UNITED STATES PATENT AND TRADEMARK OFFICE

Office Action Summary

09/940,419

DETAILED ACTION

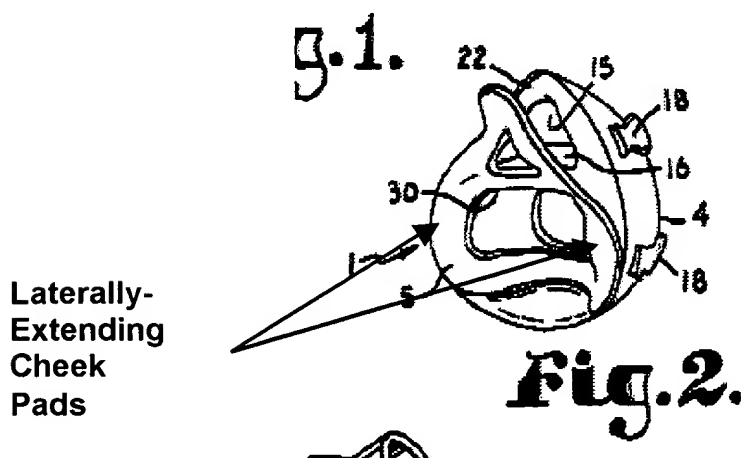
- a member (4) adapted to extend across the mouth and nose of a patient (Fig. 1);
- an opening (at 11) through said member in the region of the mouth;
- an adhesive surface (5) on the member (4) adapted to seal around the mouth and nose of the patient such that the nose is blocked and the mouth opens through said opening enabling ventilation via the mouth (Figs. 1-4).

With respect to claim 3, Rudolph discloses wherein said sheet (5) has two laterally-extending cheeks pad (see illustration of Fig. 2 below).
